EN 13445 "Unfired pressure vessels" Maintenance Help Desk (MHD) Question form

Request reference number (to be filled by MHD): (2014)-03-67				Date: 202X-xx-xx	
Please fulfil the following					
Part: EN 13445-3	Issue: 2014	Page 604	Subclause B.8.3.6.	National Standard Reference	
Subject:					
Type of request:					
<input checked="" type="checkbox"/> Technical clarification		<input type="checkbox"/> Editorial correction			
<input type="checkbox"/> Technical comment		<input type="checkbox"/> Translation correction			
From : Company: SINTRA Engineers Name: Pascal Schreurs Postal address: Poststraat 2D; Sittard			e-mail: p.schreurs@sintra-engineers.nl phone: +31 6 57 333 284		
<input type="checkbox"/> Manufacturer	<input checked="" type="checkbox"/> User	<input type="checkbox"/> Other (please specify):

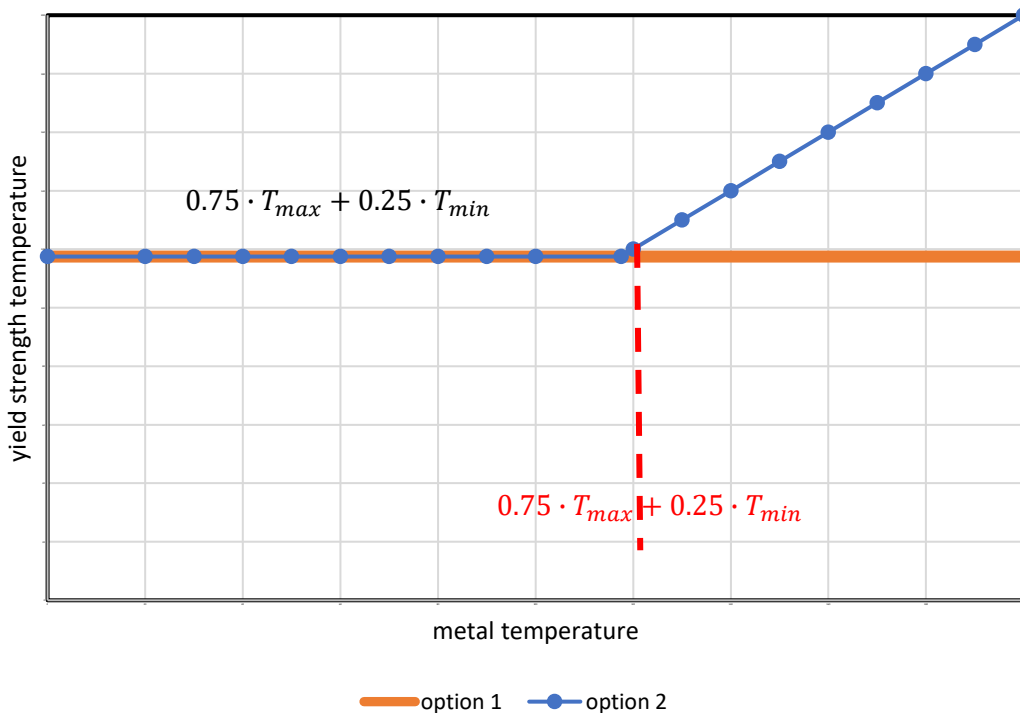
I have a question with respect to the PPD analysis from the direct route annex B. We have a discussion with a pressure vessel manufacturer about the the progressive plastic deformation design check in annex B (direct route).

The yield strength in this PPD analysis is stated in paragraph B.8.3.6. For carbon steel, the yield strength to be used in this type of analysis is written below:

“RM is given by ReH or $Rp0.2/T$, at the (time- and space-dependent) calculation temperature, or at a time independent temperature which shall not be less than $0.75 T_{max} + 0.25 T_{min}$, where T_{max} and T_{min} are the highest and lowest calculation temperatures at each point during whole action cycle”

If a thermal transient analysis is performed, the metal temperature should be used to determine the appropriate yield strength since a transient analysis is time dependent. This seems clear to me.

However, if a steady state analysis is performed, a minimum temperature of “ $0.75 T_{max} + 0.25 T_{min}$ ” may be used. How should I interpretate this?

- **Option 1:** Is the yield strength for all material determined at “ $0.75 T_{max} + 0.25 T_{min}$ ” regardless of the actual metal temperature?
- **Option 2:** Or is the yield strength determined at actual metal temperature with a minimum of “ $0.75 T_{max} + 0.25 T_{min}$ ”

In my opinion, option 2 is the correct one. Text should be changed to ensure that the maximum of actual metal temperature or $0.75 T_{max} + 0.25 T_{min}$ is used to determine the yield strength

Option two is correct. However it is not necessary to change Annex B, because this is clear in Clause 5.3.7.
